SBK-L-14102
Docket No. 50-443

Seabrook Station

License Amendment Request 14-04

Revised Reactor Coolant System Pressure - Temperature Limits Applicable for 55 Effective Full Power Years

Figure 1: WCAP-17441 P-T Limits drawn on Comparison of Seabrook WCAP-15745 P-T Limits to Inlet Nozzle Limits [the superimposed red line is the 55 EFPY 100° F/hr curve]

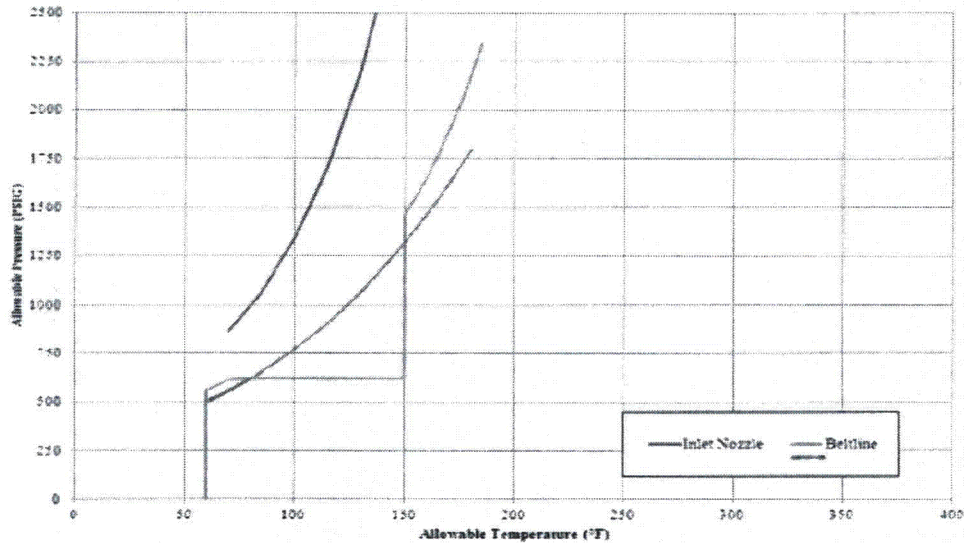
NextEra's response to the NRC's request for additional information (RAI) [Reference 5] supporting Seabrook Amendment 135 [Reference 6] discussed that WCAP-14040-A did not consider the inlet/outlet nozzles and demonstrated that the P/T limit curves are bounding for the entire reactor pressure vessel (RPV) by the development of component specific P/T limit curves for the RPV inlet/outlet nozzles. Figures 1 and 2 provided in the RAI response compared the nozzle P/T limits to the beltline P/T limits derived in WCAP-15745. The component specific P/T limit curves for the inlet and outlet nozzles that supported the RAI response as well as the proposed 55 EFPY P/T limits

were developed using 55 EFPY fluence. Utilizing the data provided in Table 6-4 of WCAP-17441-NP, the P/T limits derived in WCAP-17441-NP for the most limiting 100° F/hr cooldown case have been superimposed on those figures below and demonstrate that the beltline P/T limits derived for 55 EFPY are below and to the right of the nozzle curves and remain bounding.

FIGURE 3.4-2
 REACTOR COOLANT SYSTEM HEATUP LIMITATIONS - APPLICABLE UP TO 23.7 EFPY

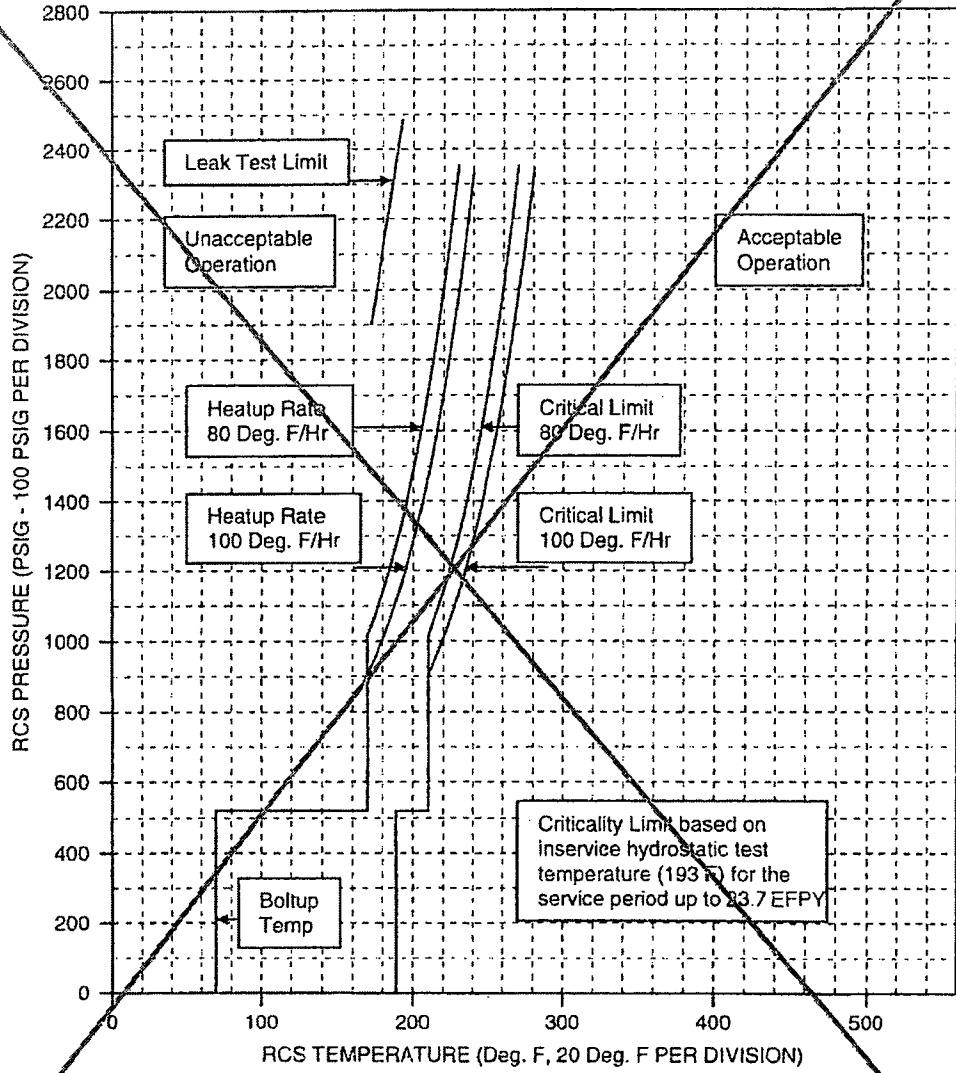
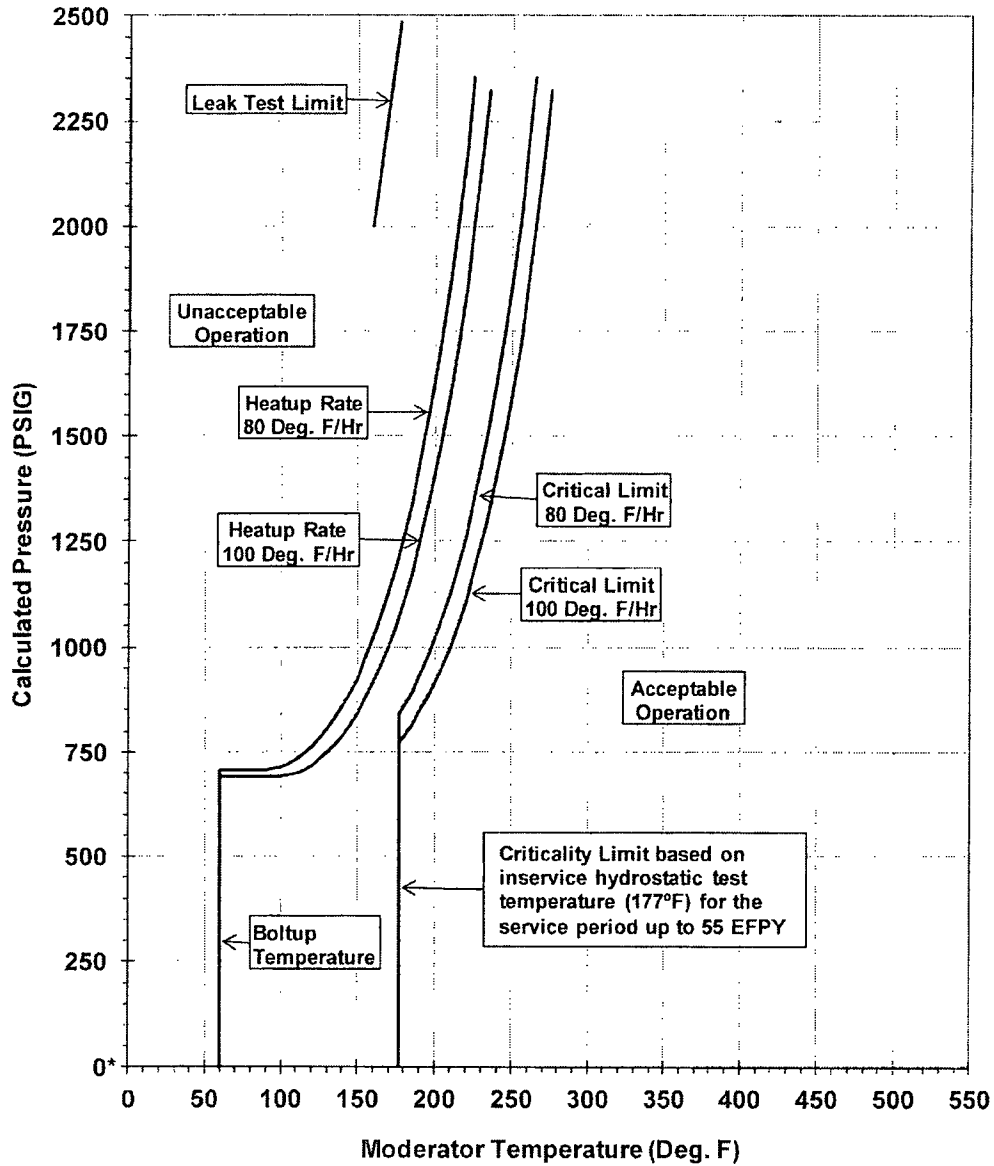
- Figure 3.4-2, Reactor Coolant System Heatup Limitations - Applicable Up to 23.7 EFPY, is replaced with a new figure applicable to 55 EFPY.
- Figure 3.4-3, Reactor Coolant System Cooldown Limitations - Applicable Up to 23.7 EFPY, is replaced with a new figure applicable to 55 EFPY.

Replace this Figure and information with the Figure and information on the following page

Limiting material: LOWER SHELL PLATE R1808-1 WITHOUT USING SURVEILLANCE DATA, POSITION 1.1

Limiting ART values at 55 EFPY: 1/4T, 117°F (Axial Flaw)

3/4T, 105°F (Axial Flaw)

Curves applicable for the first 55 EFPY and do not contain margins for possible instrument errors

* Curve is applicable during RCS vacuum fill

FIGURE 3.4-3
REACTOR COOLANT SYSTEM COOLDOWN LIMITATIONS - APPLICABLE UP TO 23.7 EFPPY

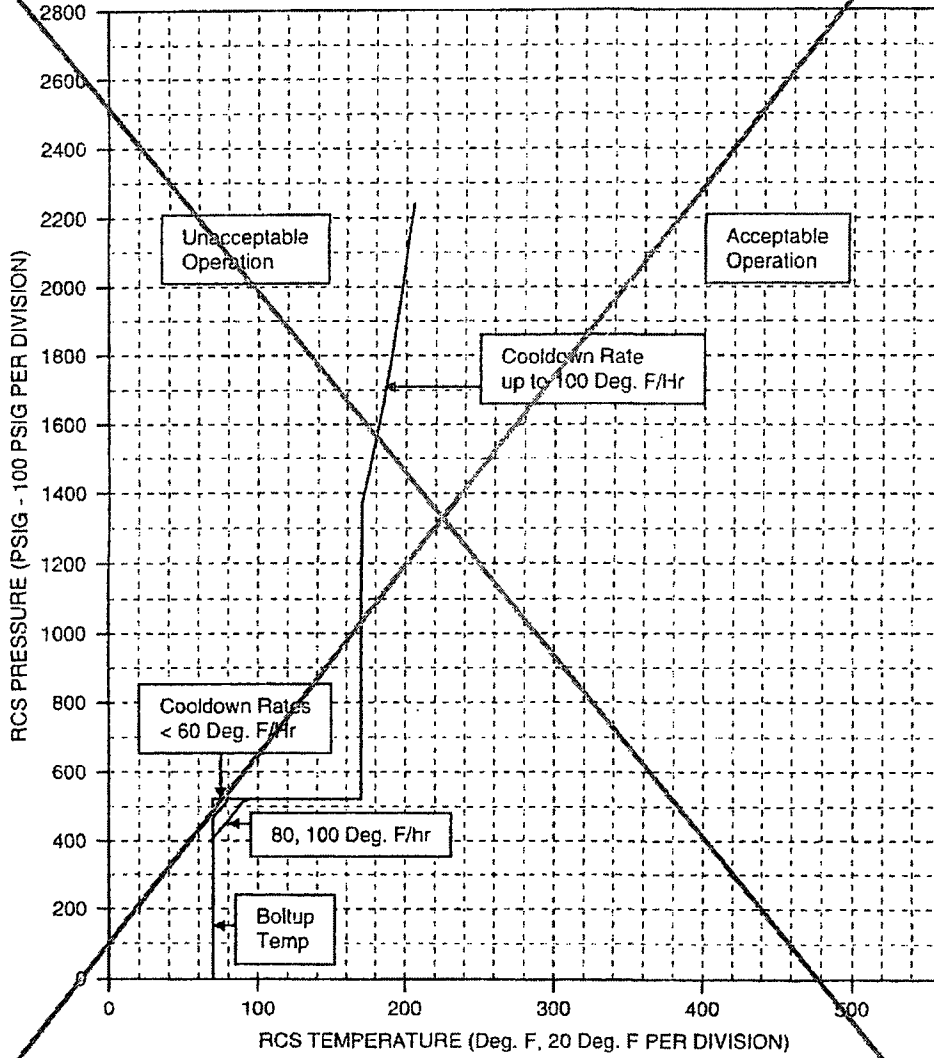
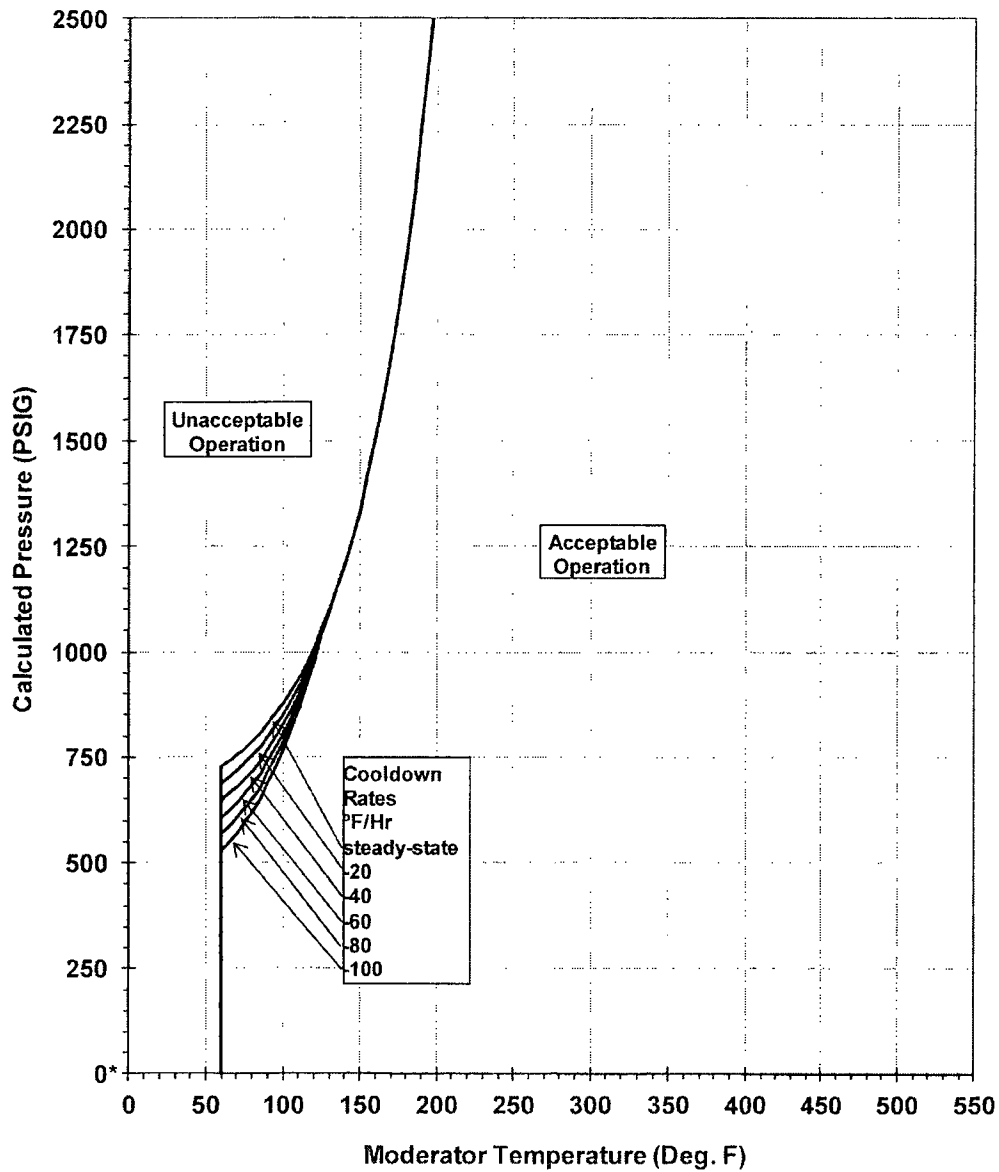
Replace this Figure and
information with the Figure and
information on the following
page.

Limiting material: LOWER SHELL PLATE R1808-1 WITHOUT USING SURVEILLANCE DATA, POSITION 1.1

Limiting ART values at 55 EFPY: 1/4T, 117°F (Axial Flaw)

3/4T, 105°F (Axial Flaw)

Curves applicable for the first 55 EFPY and do not contain margins for possible instrument errors

* Curve is applicable for RCS vacuum fill

FIGURE 3.4-4 RCS COLD OVERPRESSURE PROTECTION SETPOINTS

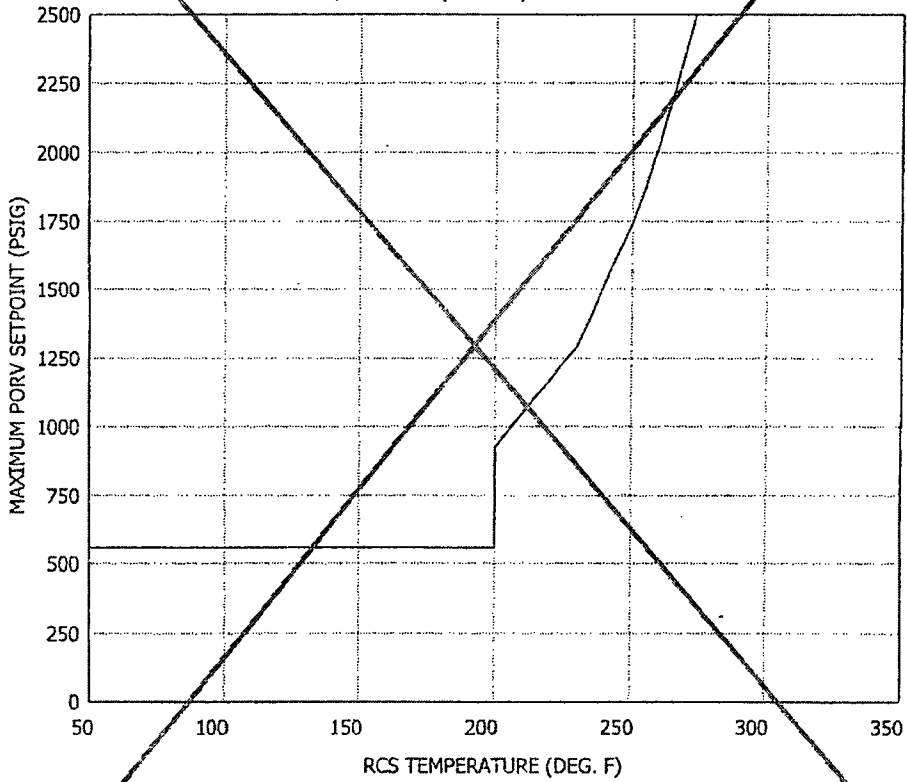
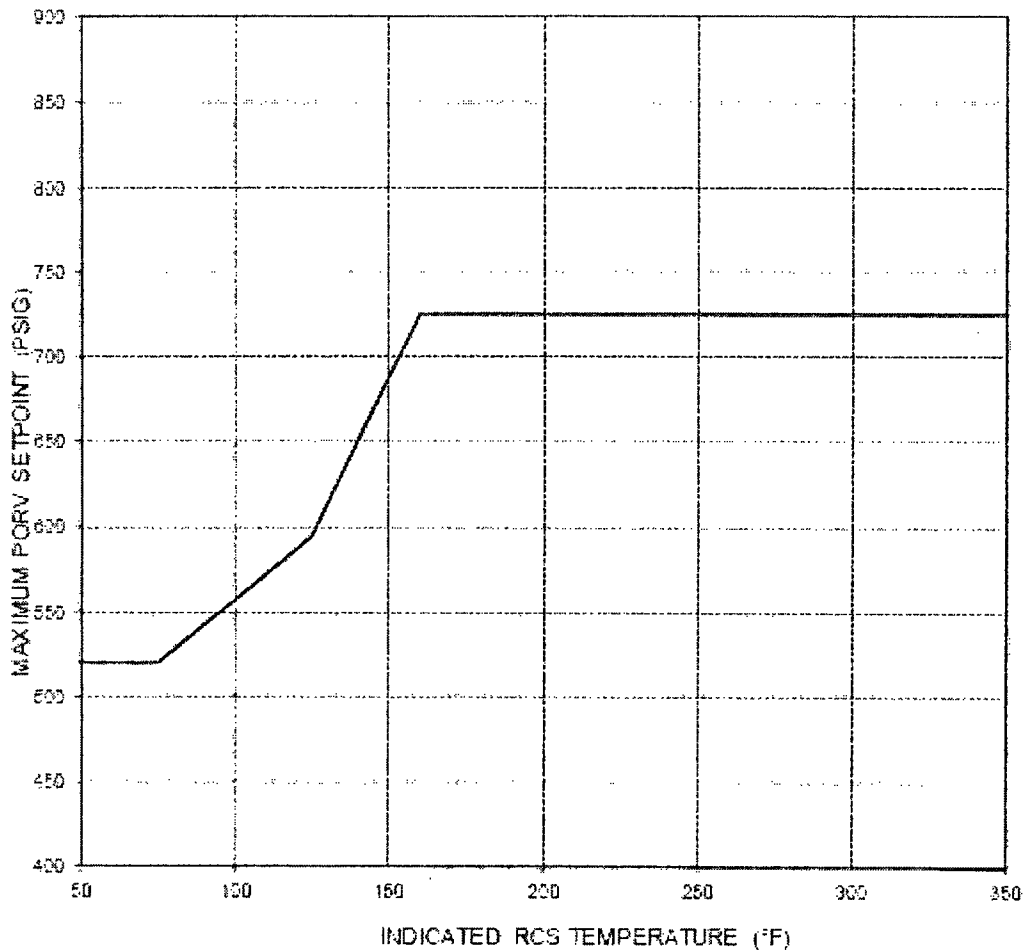
Based on the proposed P/T limit curve changes discussed above, new PORV setpoints were developed. As such, the proposed changes include a new TS Figure 3.4-4 applicable up to 55 EFPY to replace the current TS Figure 3.4-4 (applicable up to 23.7 EFPY). The proposed new TS Figure 3.4-4 is provided in Attachment 1.

Replace this figure and information with the Figure and information on the following page

VALID FOR THE FIRST 55 EPFY, MAXIMUM SETPOINT ACCOUNTS FOR INSTRUMENT UNCERTAINTIES

* Note that above the enable temperature the PORV setpoints will not restrict plant heatup and cooldown operations since COMS is not required to be armed at temperatures higher than 225°F. Hence the PORV setpoint values ramp up to the nominal setpoint value of 2385 psig is not shown.
